VIBE CREDIT UNION HEADQUARTERS MAINTENANCE & SITE IMPROVEMENTS JSP21-32

Consideration at the request of Nowak & Fraus Engineers, for approval of a Revised Landscape Plan. The subject property is approximately 9.84 acres and is located west of Cabaret Drive and south of Twelve Mile Road in the OST, Office Service Technology, Zoning District. The applicant is proposing landscape changes to the site as part of minor site improvements that require Planning Commission consideration.

PLAN REVIEW CENTER REPORT

PLAN REVIEW CENTER REPORT
May 13, 2022
Vibe Credit Union HQ Parking
Revised Preliminary/Final Site Plan - Landscaping

SHEET
 Tree Preservation Plan

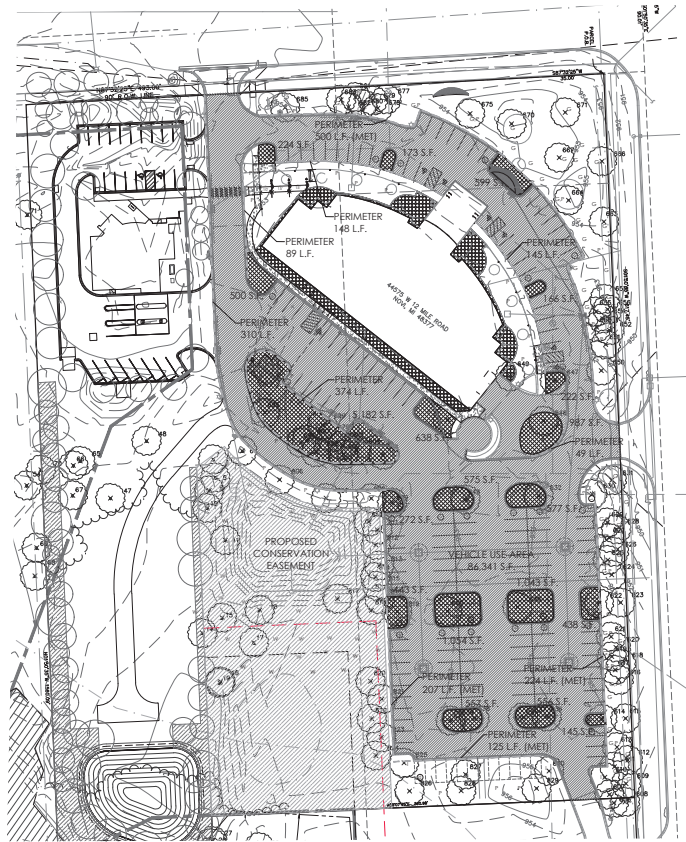
Lack of parking lot perimeter canopy trees provided along the west side of the south parking lot – *supported by staff as that area is populated by existing woodland replacement trees that would be damaged by planting the required perimeter parking lot trees.*

1. The parking lot layout is not changing beyond what was previously approved.
2. For the existing layout, 3,932sf of interior landscape area and 20 trees are required. 14,331sf of interior area and 20 trees are provided.
3. Based on the parking lots' perimeter length, 62 trees are required. 56 trees are provided.
4. **A landscape waiver to not provide perimeter trees along the western side of the southern parking lot is requested (207lf or 6 trees).** *It is supported by staff as the original development put woodland replacement trees along that side of the parking lot, so there is no room for the required perimeter trees.*

- Landscape Waiver, for the Perimeter Parking Lot tree requirement, if approved by the Planning Commission will be provided on the plan, Sheet L1, verbatim to the language approved.
- At least one of the species provided on the plan will be substituted to a native species, to comply with the 50% native species requirement.
- Planting details will be made larger.

SHEET
Landscape Notes
and Details

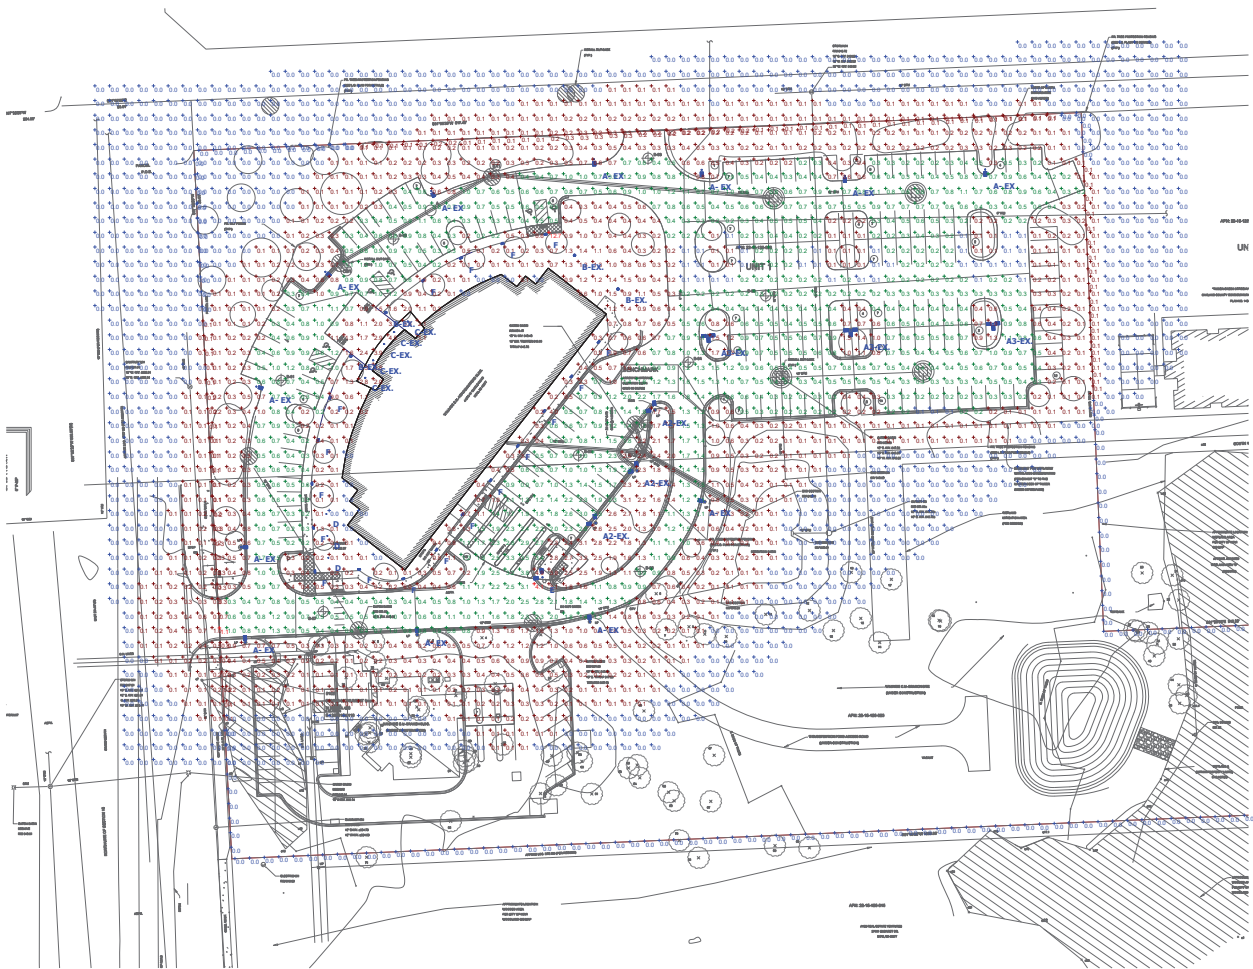
Since there is room, please make the details larger for easier reading by the contractor.
